**R10RW**

Blue Bird has decided that a defect which relates to motor vehicle safety exists on certain 2004 through 2009 model year "Vision" conventional **school buses** manufactured from January 30, 2003 through September 24, 2008.

# Incorrect Power Cable Lug Orientation

Models Affected: 2004 through 2009 Vision

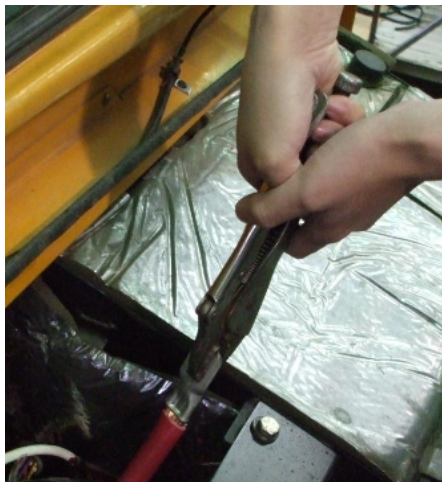
4. Inspect the electrical cable connections at the Power Stud and Aux Power Stud, if installed. See the diagram below to determine if the cables were installed correctly. ALL terminal lugs on each power stud should be oriented such that the barrel of the lug is further away from the mounting surface of the isolated stud. The flat side of terminal end (lug) must be down.

5. If the cables were installed incorrectly, remove the nut securing the cables. Then remove the cables and reinstall correctly per the diagram above. Make sure the terminal lugs are fanned out on the stud as opposed to directly on top of each other. Vice-grip pliers are recommended when turning incorrectly installed cable terminal lug to the correct orientation of flat side down.

6. Secure the cables with the nut and torque to 12 to 15 ft-lbs.
7. Apply corrosion resistant coating (glyptal) as required to prevent corrosion.

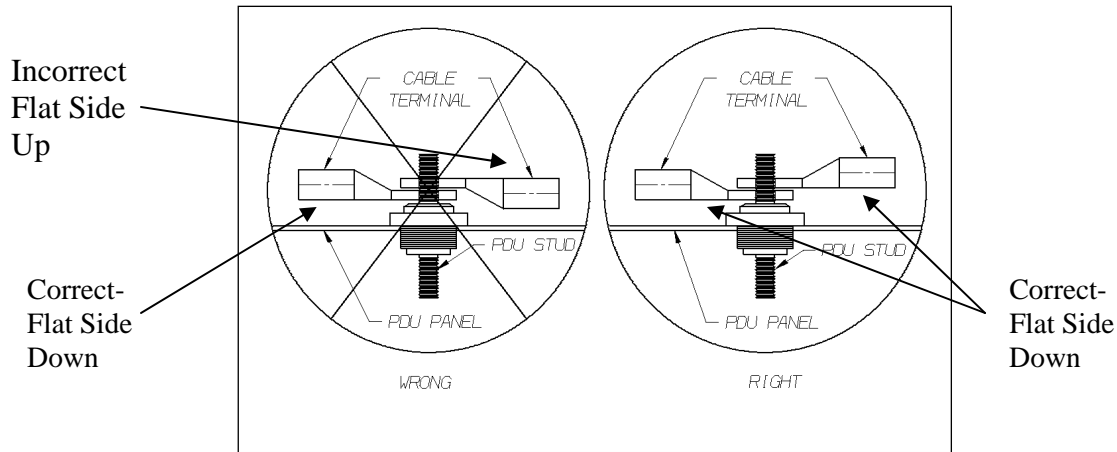
ALL terminal lugs on each power stud should be oriented such that the barrel of the lug is further away from the mounting surface of the isolated stud. The flat side must be down.

11. Remove the nut securing the cables. Then remove the incorrectly installed cables and reinstall correctly with flat side down. Make sure the terminal lugs are fanned out on the stud as oppose to directly on top of each other.
12. If needed, use vise grips to rotate cable so lug fits with flat side down. See photo on page 2.
13. Secure the cables with the nut and torque to 12 to 15 ft-lbs.
14. Apply corrosion resistant coating (glyptal) as required to prevent corrosion.
15. Reinstall the red protective covers.
16. While having access to this area, inspect ALL power cables for any evidence of contact with the rear of the engine, chaffing, or other damage. **Ensure clearance between power cables and any part of the engine is more than ½ inch.**
